Letter of Explanation

CONFIRMATION OF PRE-FILE (2024-0109-P)

The applicant seeks approval to construct a detached 10' by 20' (200 square foot) deck in the front (waterfront) yard. The proposal would necessitate variances to allow new Critical Area lot coverage nearer to the shoreline than the closest facade of the existing principal structure, to allow disturbance to slopes of 15% or greater in the LDA, and to allow an accessory structure with less setbacks than required.

Proposed 10x30 Open Deck

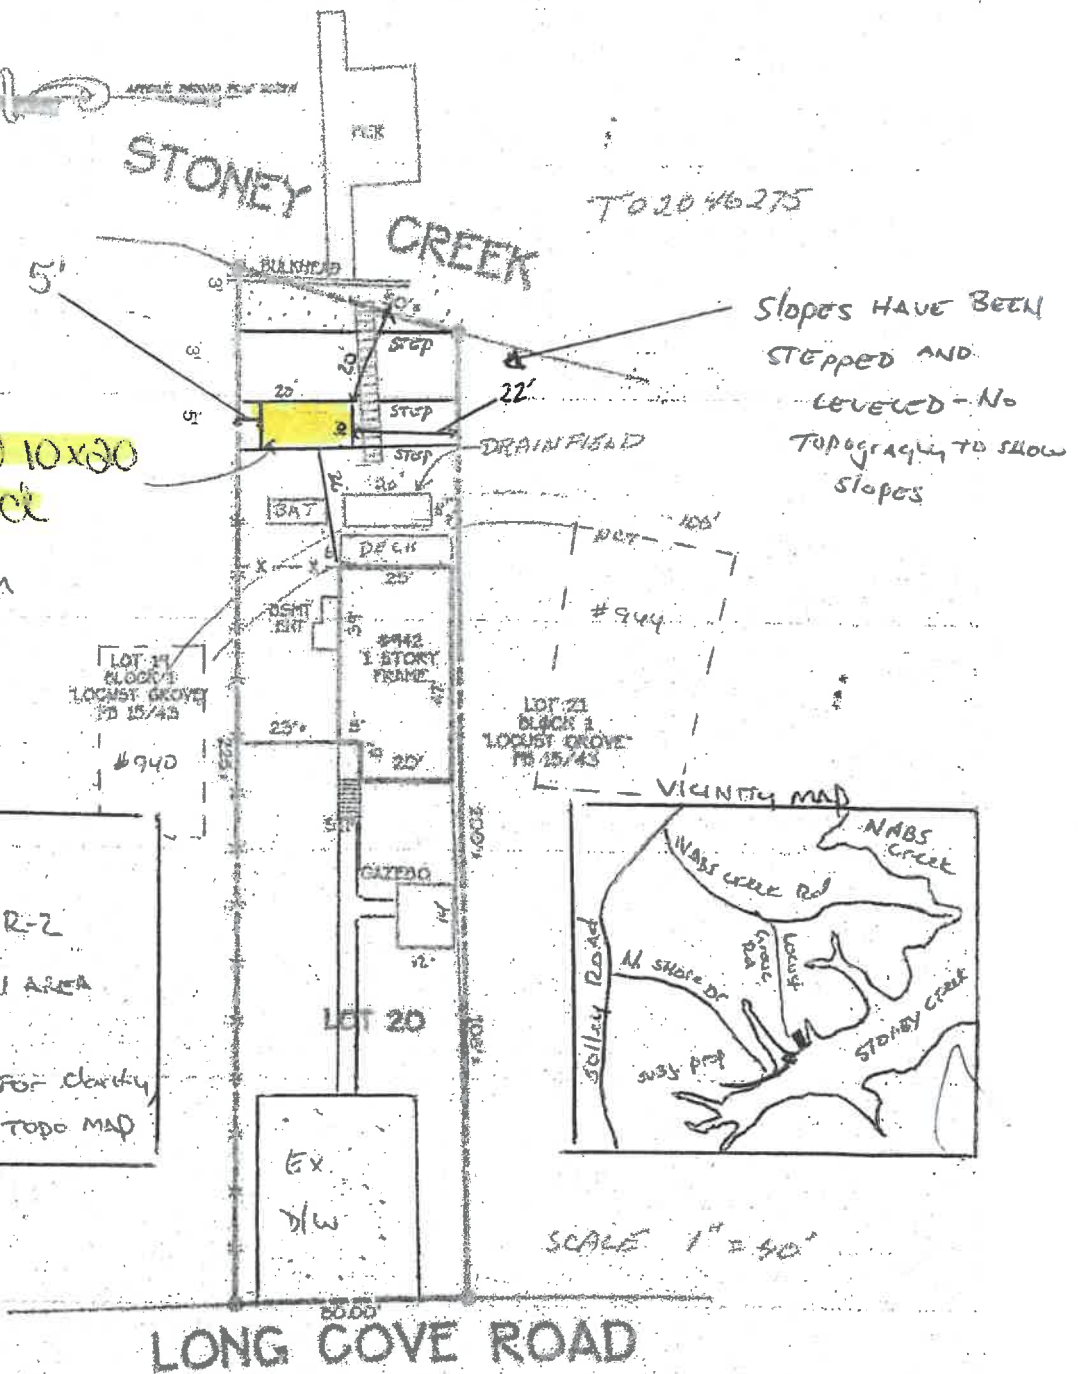
The **Critical Area Team** commented that they cannot support this request. COMAR defines lot coverage as the percentage of a lot that is covered with gravel, stone, shell, decking, etc. The proposed improvement qualifies as decking and does not qualify for the exemption for a deck.

The **Zoning Administration Section** concurs with the Critical Area Team that a detached deck is considered critical area lot coverage and that the critical area variance to allow 200 square feet of new critical area lot coverage between the house and the shoreline (and only 20 feet from the shoreline) cannot be supported. If all portions of the proposed deck (including the deck rails) are less than eight above grade, then the side setback requirement would be reduced to five feet. In order for a Critical Area variance to be approved, the applicant must demonstrate and the Hearing Officer must find that the proposal complies with each and every one of the Critical Area variance standards provided under Section 18-16-305(b) and (c) of the Anne Arundel County Zoning Ordinance.
